AGENDA OF THE REGULAR SESSION
CITY OF AUBURN
HISTORIC DESIGN REVIEW COMMISSION

ITEM V-A: HISTORIC DESIGN REVIEW – 935 LINCOLN WAY (JACOBS BUILDING FACADE) – FILE HDR 13-12.

ITEM V-A: HISTORIC DESIGN REVIEW – 958 LINCOLN WAY (LA FORNARETTA RESTAURANT) – FILE HDR 13-13.

2 FRONT/NORTHWEST EXT'R. ELEVATION: PROPOSED FASCIA MODIFICATION

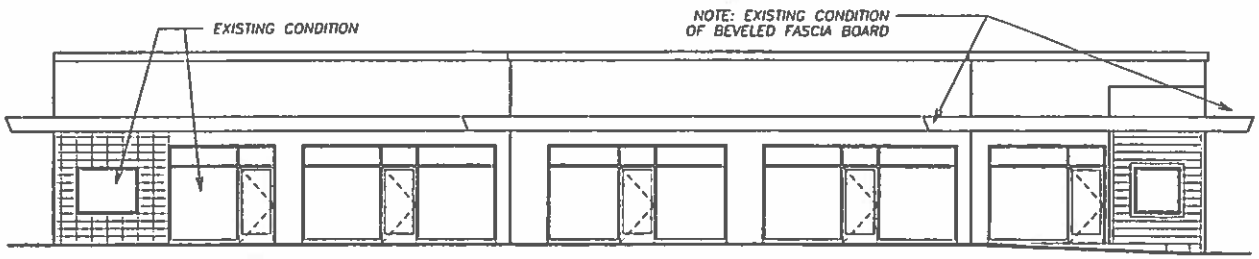
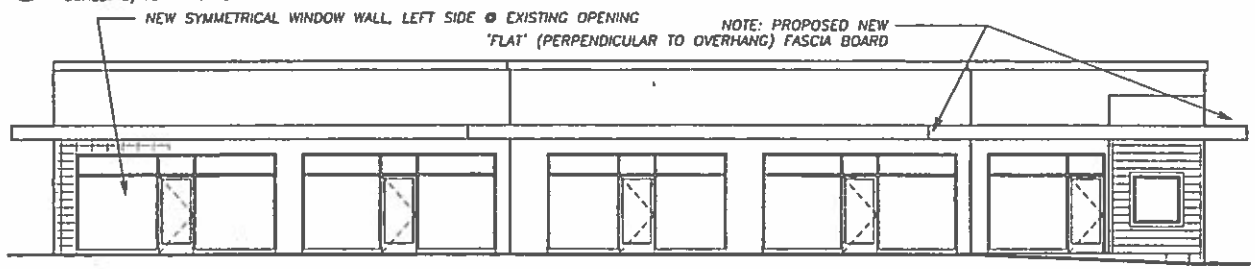
The applicant proposes to alter the building façade, which includes removing the existing 4°4° northern window and replacing the window with a 5°6-6 window. The proposed window replacement will replicate the other 5°6-6 metal framed windows on the building fronting Lincoln Way.

Additionally, the applicant is proposing to square off the existing beveled fascia along the Lincoln way frontage (**Exhibit B**).

As noted, the proposed replacement of the 4°4° window with a 5°6-6 window will replicate the other Nine 5°6-6 windows along Lincoln Way. As conditioned, the window replacement will match the existing windows, which are metal framed.

3. Prior the issuance of a building permit, the new window and materials shall match the existing windows and materials on the building, which shall be reflected on the building plans.

FRONT ELEVATION

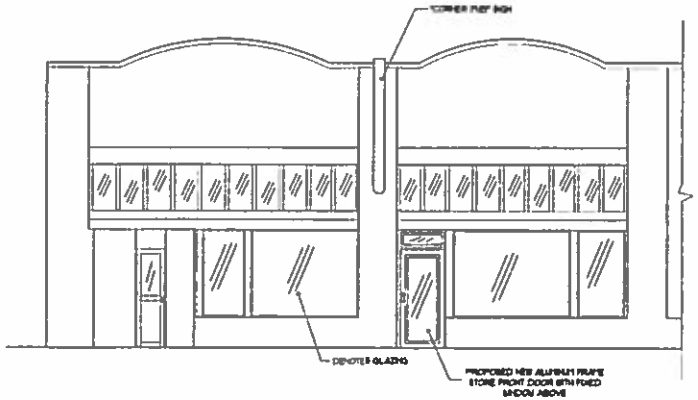
The applicant requests Historic Design Review Commission approval to add a door on the front building façade. The new door will replace the existing 3°6° window. Note that staff had initially recommended a wood door in lieu of an aluminum frame door to match the wood windows. In response, the applicant submitted a wood door product sheet for the proposed wood door in lieu of the aluminum frame door shown on the plans. The proposed door, with fixed transom above, is a natural wood color Douglas Fir Thermal French Door (**Exhibits B & C**).

Removal of the original window would alter the structure from its original design; however, the proposed wood door will match the original wood windows and could be removed in the future thereby retaining the essential form and integrity of the structure.

In staff's opinion, replacement of the 3°6° with the proposed wood framed door with fixed transom above, is consistent with the applicable *Historic Preservation Architectural Design Guidelines* and *Secretary of the Interior Standard's.*

3. Prior the issuance of a building permit, the plans shall be revised to note that the door shall be wood framed to match the existing wood windows on the building.

FLOOR PLAN MODIFICATION

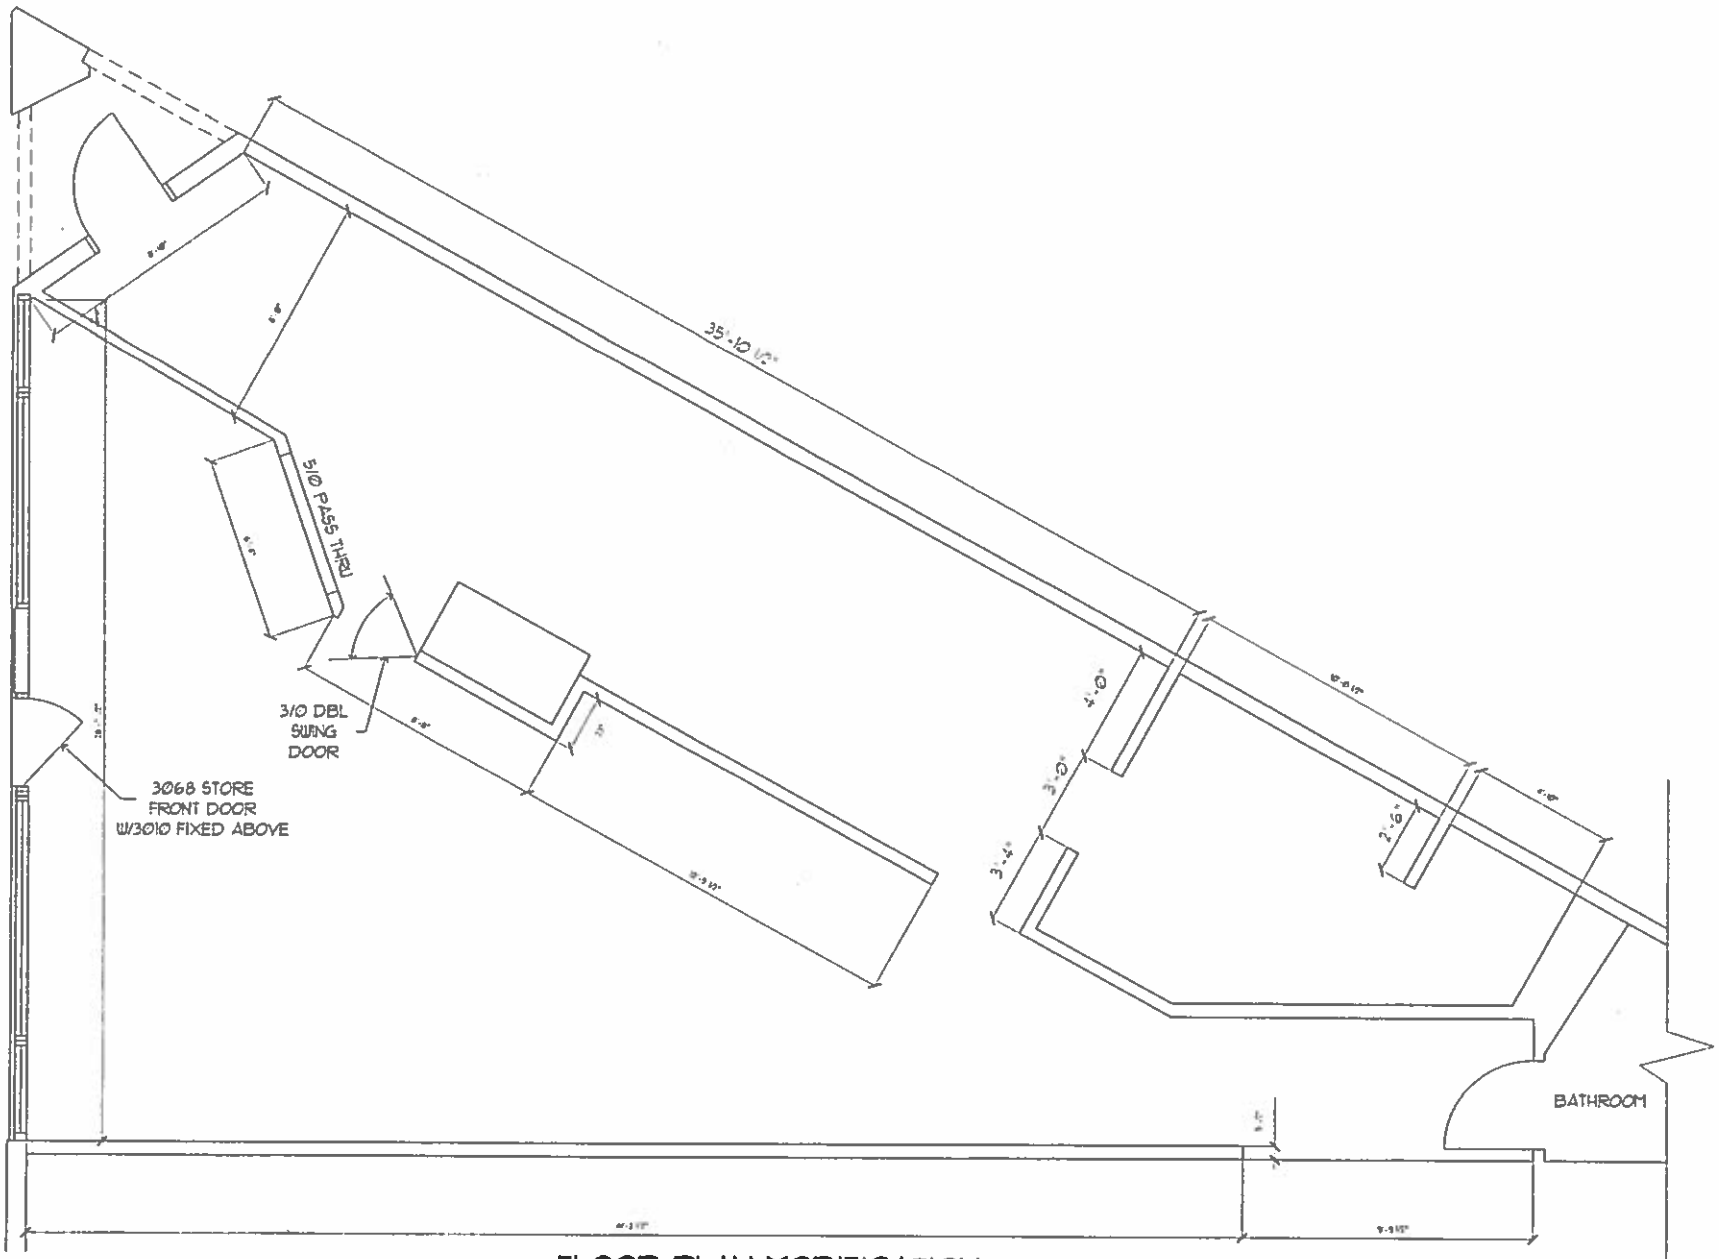
The applicant has indicated that the proposed future tenant, La Fornaretta Restaurant, desires to utilize the existing door as a service entrance and plans to fence off the front of the building and add tables and chairs for an outdoor seating area. The proposed new door will provide direct access to the future outdoor seating area.
